STAFF REPORT

Subject: Sketch Plan Review – Cross Roads (7200 & 7250 France Avenue)

RE: Crossroads Sketch Plan review by Three Rivers Park District

Future Land Use Plan with Building Heights

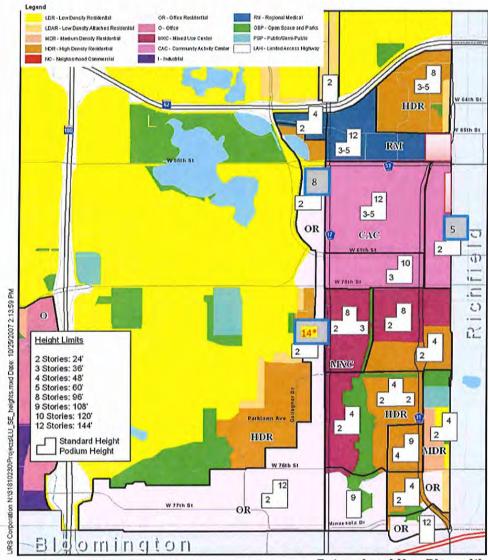
The prosed FAR for this project is 1.6. FAR is not necessarily a good indicator of residential density; rather a more appropriate measure is units per acre. If you compare a retail or office development at an FAR of 1.5 (220,000 square feet of development), the amount of traffic generated from that size of a development would be greater than the 220,000 square foot development proposed consisting of primarily housing with only 20,000 square feet of retail. Therefore, staff believes that a residential density of 50 units an acre is appropriate in the OR District. The following provides an example of the comprehensive plan amendment required:

* Height may be increased to 14 stories subject review and approval of City Council.

Nine Mile Creek Regional Trail, Edina East Sec. - Three Rivers Park District

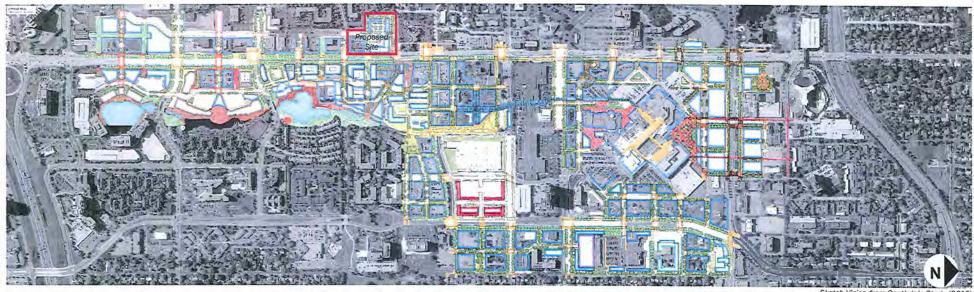
- The Regional Trail is on the south side of Gallagher Drive as it approaches France
 Avenue. As part of the project, upgrades were made to the pedestrian ramps and signal
 systems to make the at-grade crossing of France Avenue safe and fully compliant with
 current design standards. As proposed in the Sketch Plan, that at-grade crossing would be
 severely impacted by the proposed bridge landing on the east side of France Ave.

- 2. The Sketch Plan proposes to reroute the regional trail from the south side of Gallagher to the north side of Gallagher to provide the proposed ramp access for the trail to get up to bridge level. As proposed, the crossing of Gallagher is mid-block and not at a recognized intersection. Mid-block crossings are considered to have the greatest safety risk of all atgrade crossings, and are avoided in trail design whenever possible. In addition, the proposed mid-block crossing would be very close to the France/Gallagher intersection, adjacent to the development parking ramp entrance on the west, and adjacent to proposed parking spurs on the east.

- also unclear if there would be sufficient space to accommodate the bridge ramp and an atgrade sidewalk in this area.
- 5. City staff has indicated that the proposed bridge across France Ave. is not considered part of the development. A signature bridge such as this would lend great value to the development, but it is questionable if there would be other public benefit beyond its aesthetic value. As currently configured in the Sketch Plan, it would not be functionally safe for use as a regional trail component.
